PROPOSED BROWSE TO NORTH WEST SHELF PROJECT

**Supplement Report to the Draft Environment
Impact Statement (EPBC 2018/8319)**

**Under the Environment Protection and Biodiversity
Conservation Act 1999 (Cwlth)**

JULY 2022

Figure 1-2 Proposed Browse Trunkline (BTL) route

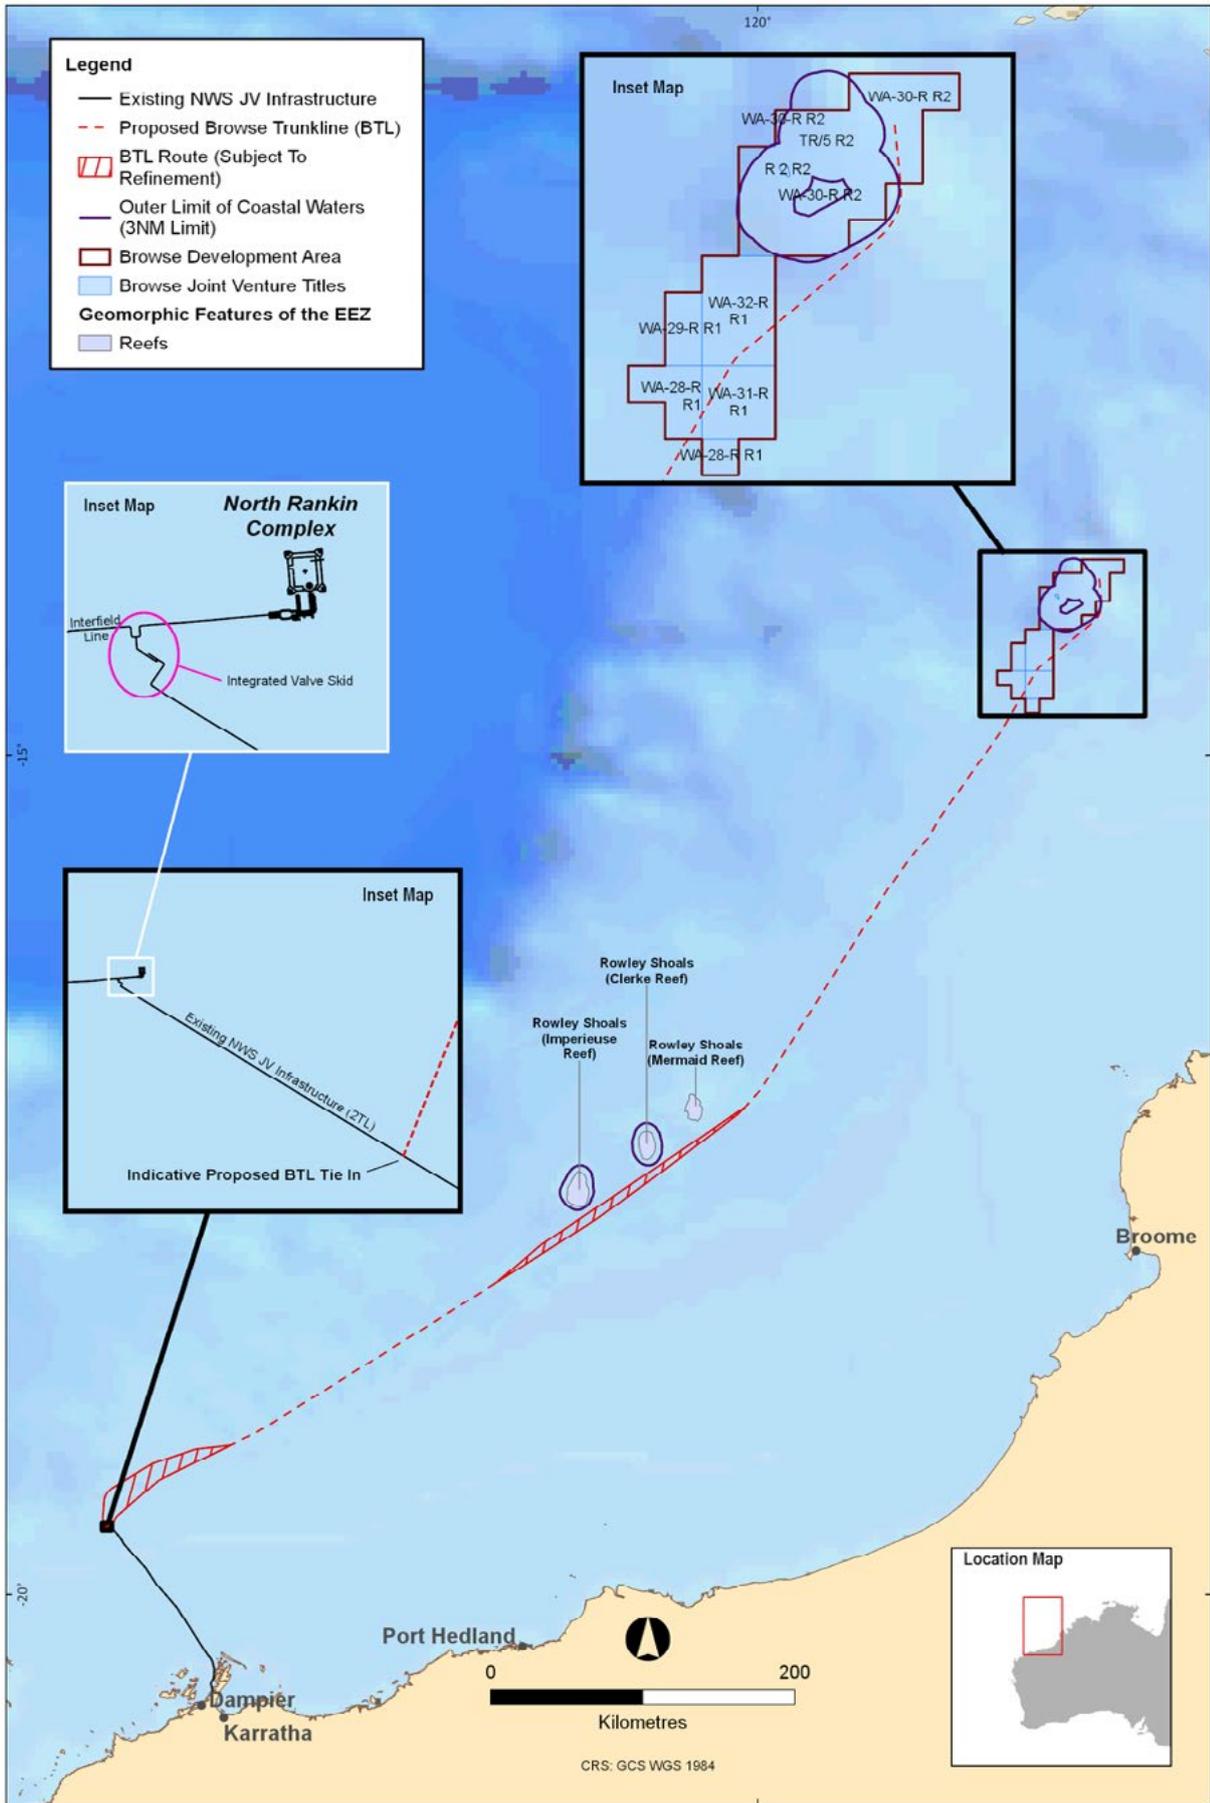
<p>4 The draft EIS/ERD needs clarification of the final BTL route and whether it will go closer or inside the Mermaid Reef Marine Park and inside the Mermaid Reef and Commonwealth water surrounding Rowley Shoals Key Ecological Feature (KEF).</p>	<p>As shown in Figure 1-2, the BTL route is subject to refinement, particularly near the Rowley Shoals and the tie-in point near NRC. The hatched area shown in Figure 1-2 represents the area in which the final route will lie.</p> <p>Woodside confirms that:</p> <ul style="list-style-type: none"> With reference to the proposed BTL route, the final BTL route will lie within the hatched area shown in Figure 1-2 and the area at this hatched area will not be moved closer to Mermaid Reef Marine Park. The BTL route will not enter the Mermaid Reef Marine Park.

As detailed in Chapter 3 of the draft EIS/ERD, a BTL route corridor has been proposed, with the final route to lie within the defined corridor (**Figure 1-2**).
